<b>Project</b>	Steamboat Base Village Redevelopment	<b>Date</b>	07/30/2021
<b>Project Location</b>	Steamboat, Colorado	<b>Architect's Project Number</b>	03.7835.000
<b>Owner/Client</b>	Alterra Mountain Company / East West Partners	<b>File</b>	6BL <b>This is page</b> 1 of 3
<b>To</b>	Saunders Construction Inc.	<b>Attention</b>	Bryan Sculthorpe
<b>Address</b>	86 Inverness Place North		
<b>City</b>	Englewood	<b>State</b>	CO <b>Zip Code</b> 80112
<b>Delivered via:</b>	<input type="checkbox"/> Messenger	<input type="checkbox"/> Hand carried	<input type="checkbox"/> Facsimile
	<input type="checkbox"/> Express	<input type="checkbox"/> Pick-up	<input type="checkbox"/> E-mail Address
	<input type="checkbox"/> Mail	<input type="checkbox"/> UPS	<input checked="" type="checkbox"/> Website Address BIM360

**Attachments** BP3 PROMENADE - BULLETIN 06

## Description of Changes

- Updated steel for plaza building revisions
- Updated plaza building footprint and shaft opens
- Added slab step plan
- Updated underground MEP to match Bulletin 06

**1A-A1.201S**

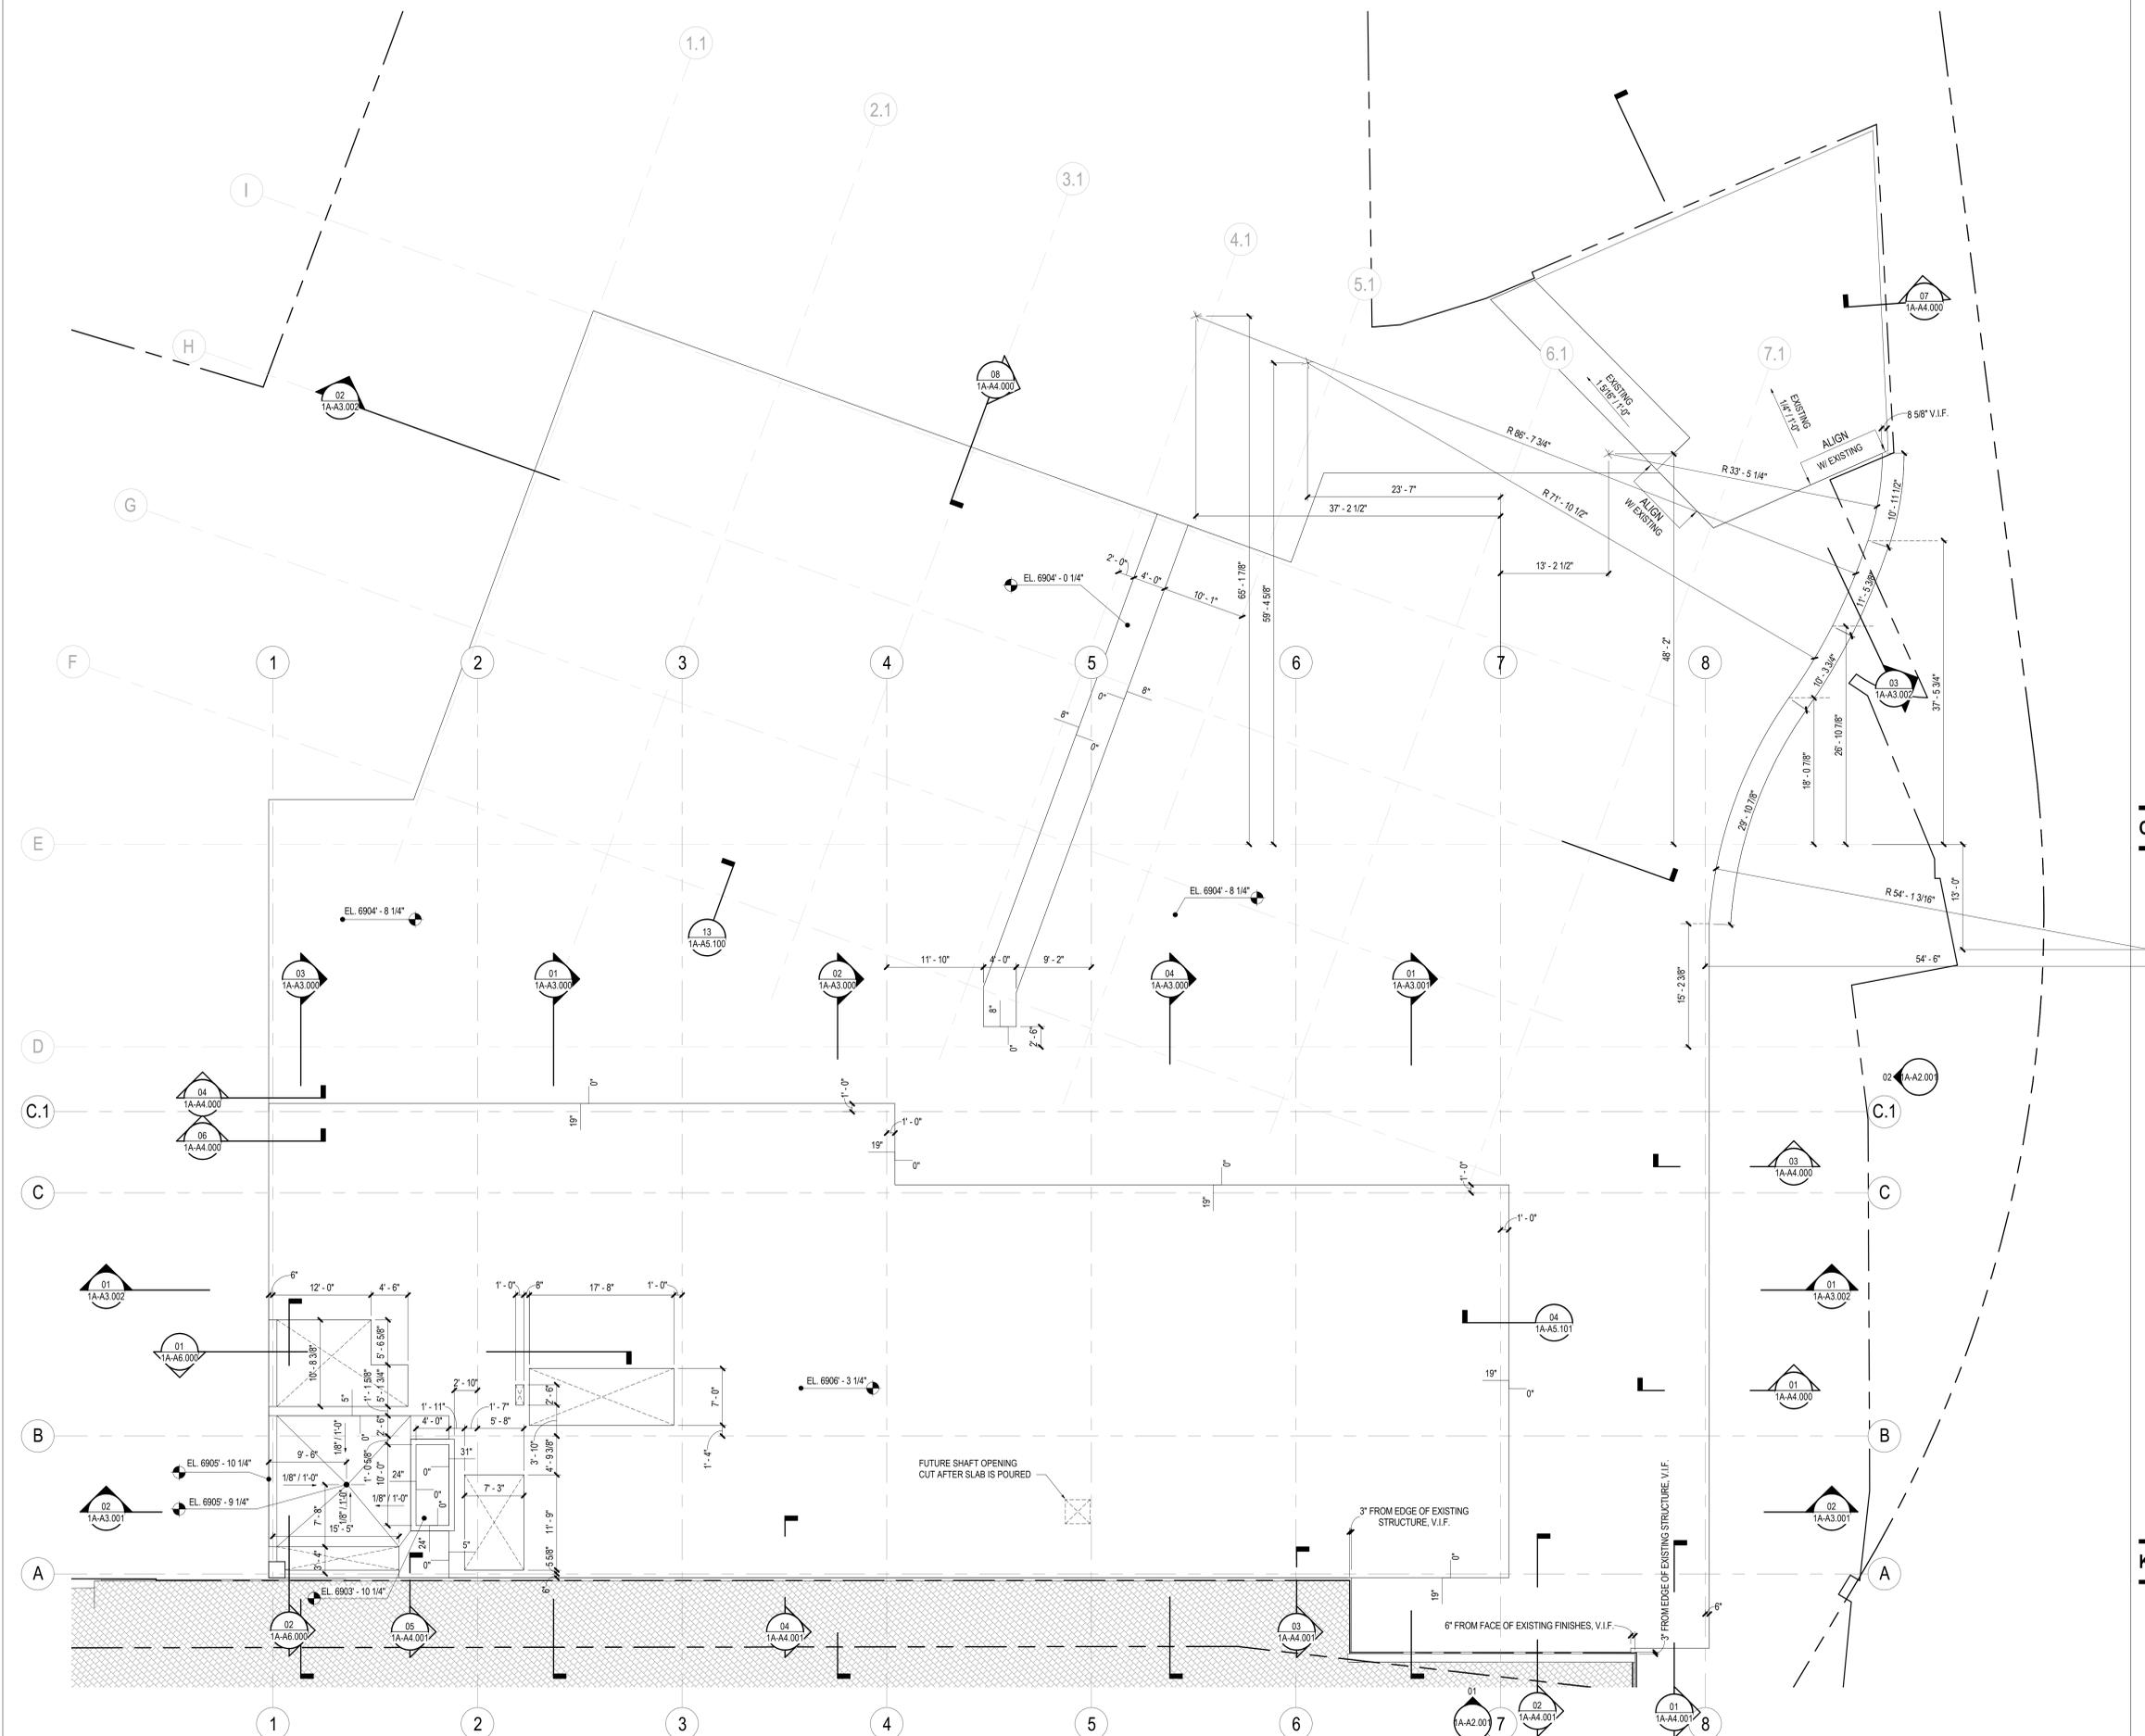
- 1. 1A-A1.200
  - a. Added clarifying dimensions
- 2. 1A-A1.201
  - a. Revised shaft openings and plaza building footprint
  - b. Added floor drain to Zamboni garage
  - c. Removed dimensions on slab plan (see 1A-A1.201S)
- 3. 1A-A1.201S
  - a. Added dimensioned slab step plan

Description  
**PROMENADE - PLUMBING UNDERGROUND PLAN - LEVEL 00**

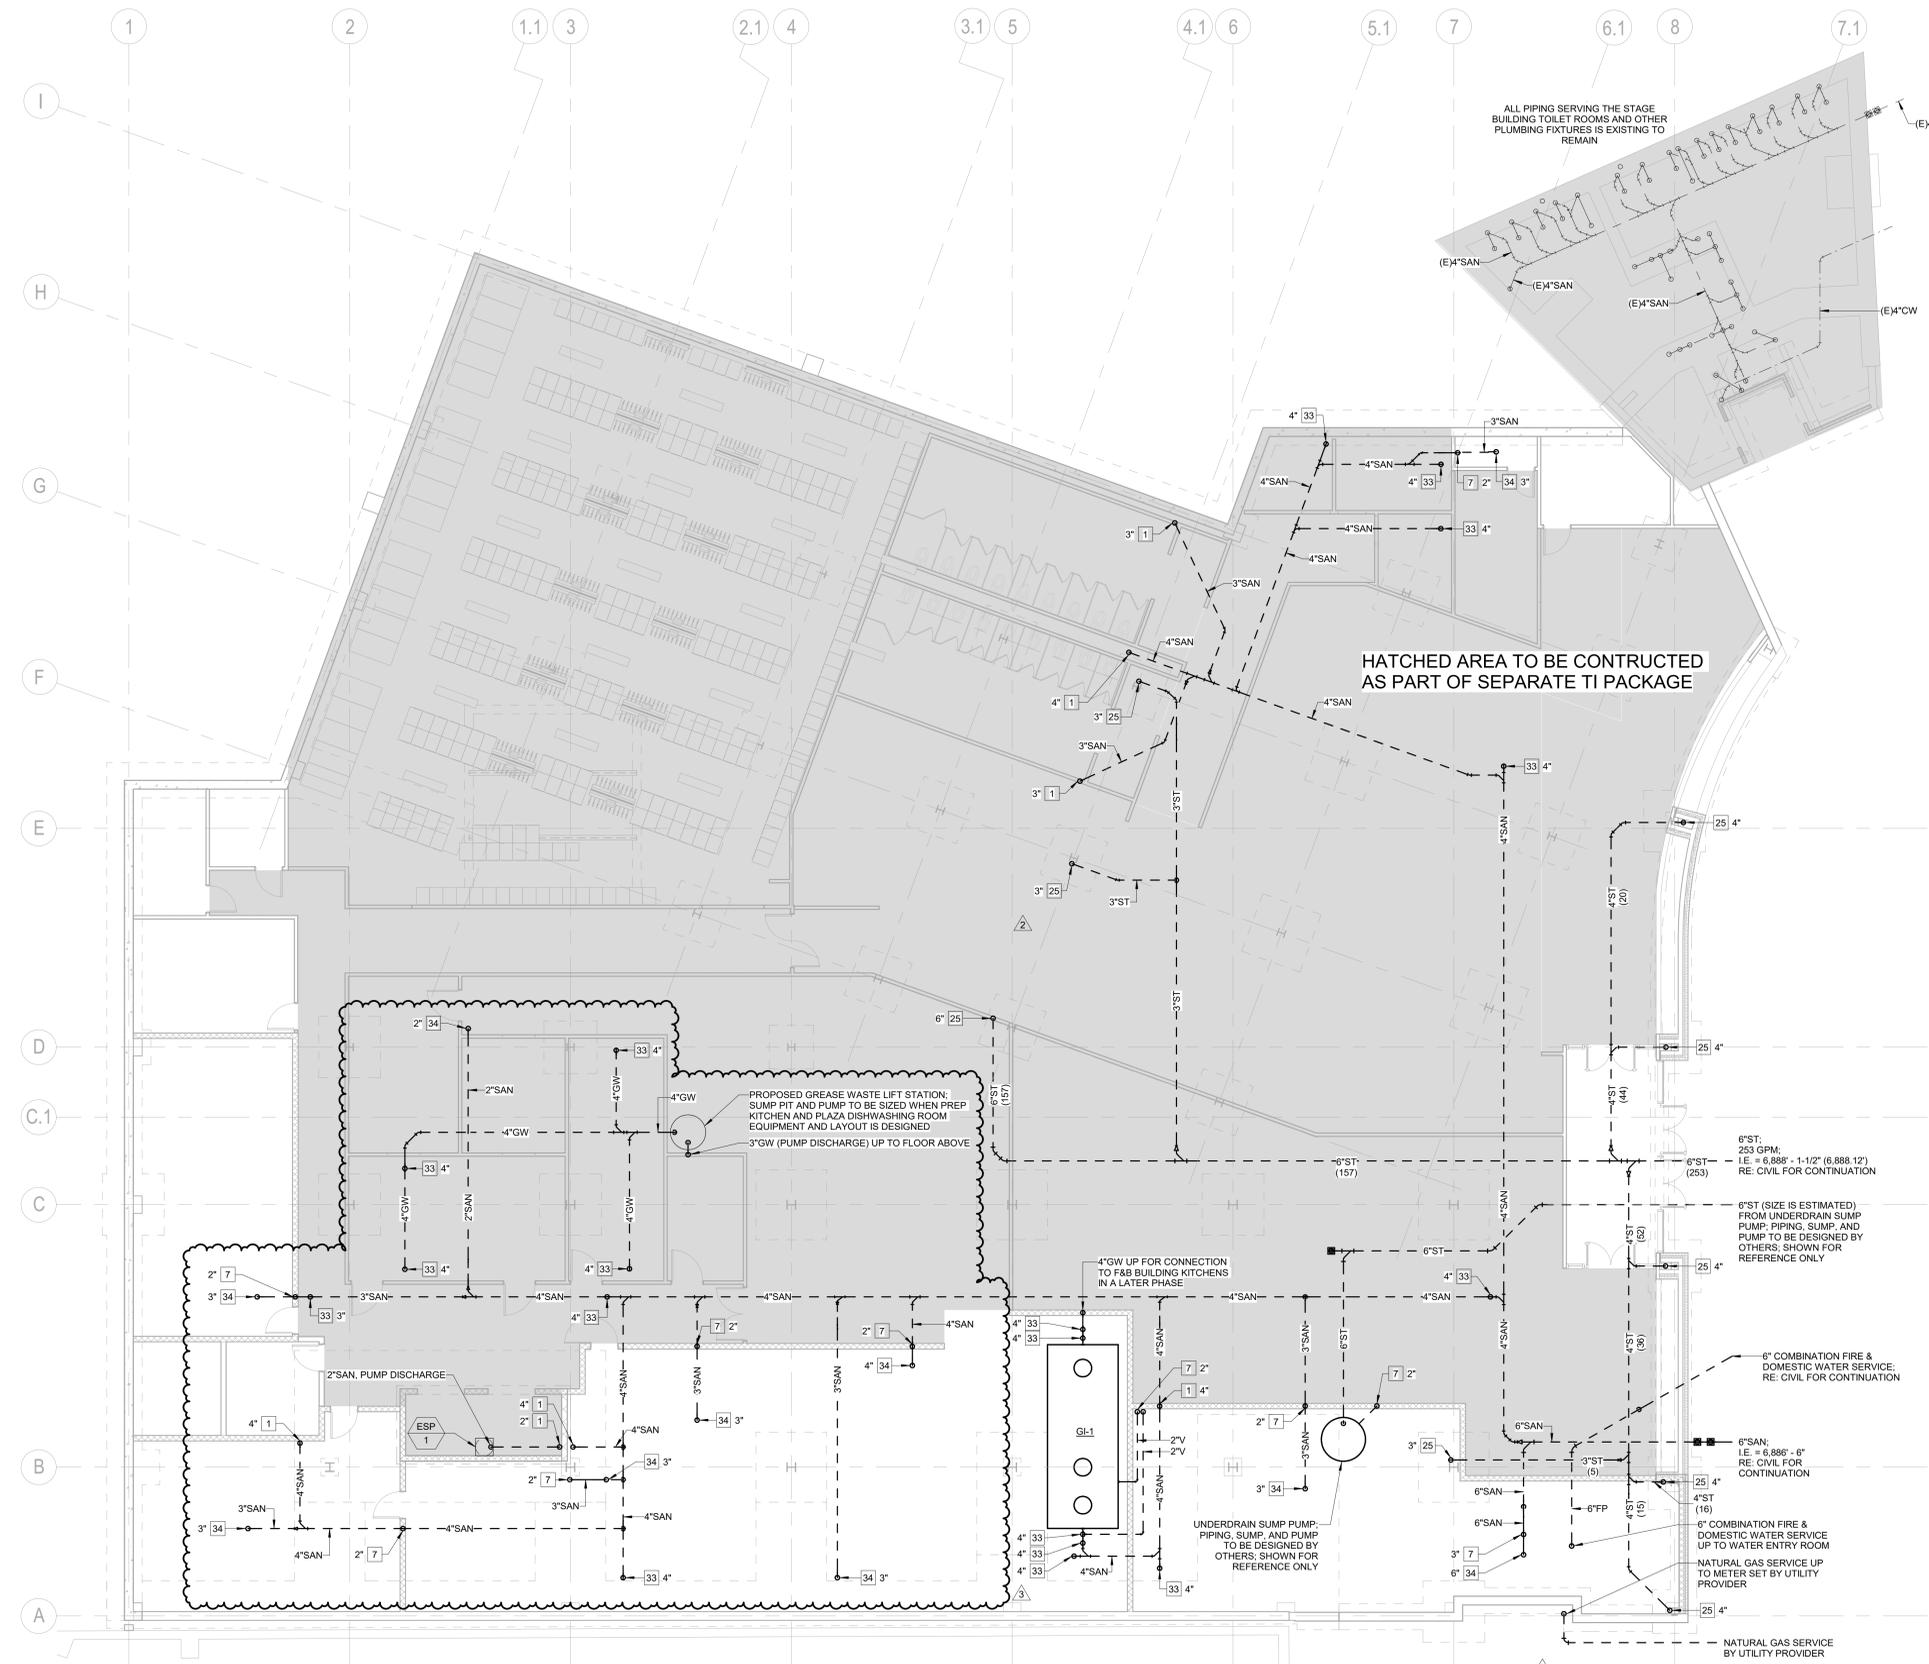
- 1. 1A-P1.199
  - a. Revised underground piping per new building layout.
- 2. 1A-P1.200
  - a. Revised layout of floor cleanouts and drains per new building layout.

**1A-E1.100U**

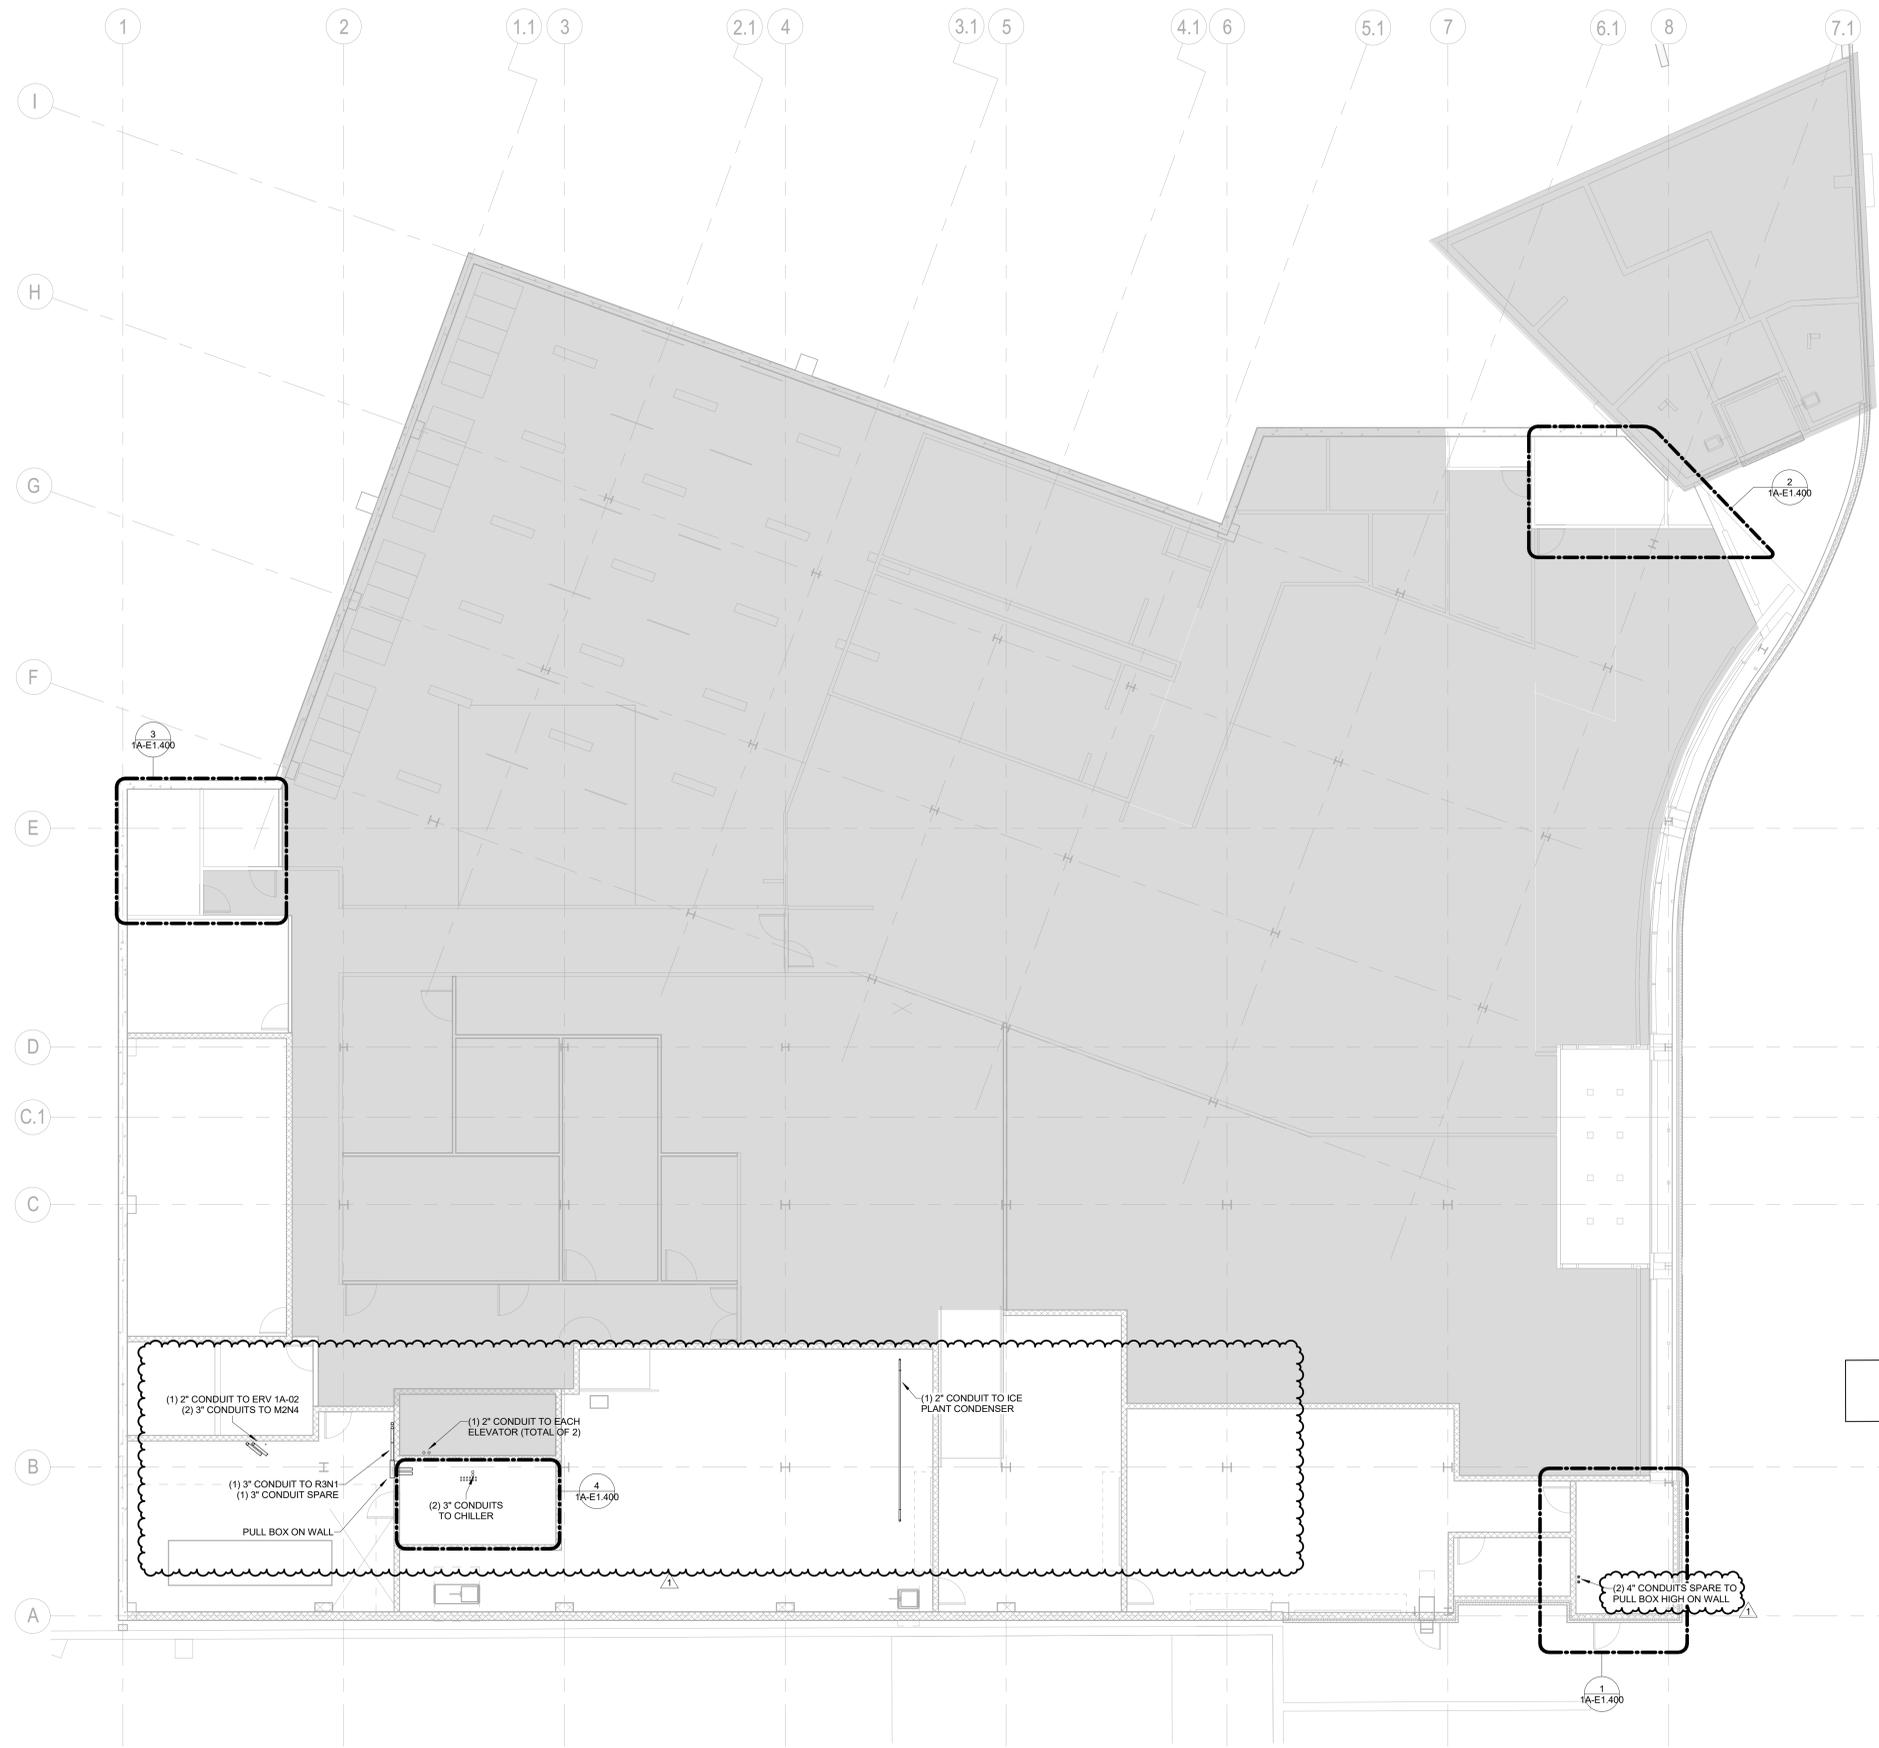
- 1. 1A-E0.001
  - b. Modified electrical one-lines to remove disconnect from secondary of transformer PBDB with relocation of transformer to electrical room 106.
- 2. 1A-E1.100U
  - a. Modified electrical underground conduit routing for revisions to plaza building and promenade level.
- 3. 1A-E1.100
  - a. Modified electrical conduit routing for promenade level for revisions to plaza building and promenade level.
- 4. 1A-E1.101
  - a. Modified electrical conduit routing for plaza level 1 for revisions to plaza building and promenade level.
- 5. 1A-E1.102
  - a. Modified electrical conduit routing for plaza level 2 for revisions to plaza building and promenade level.
- 6. 1A-E1.400
  - a. Modified electrical room layouts for revisions to plaza and promenade building and promenade level.
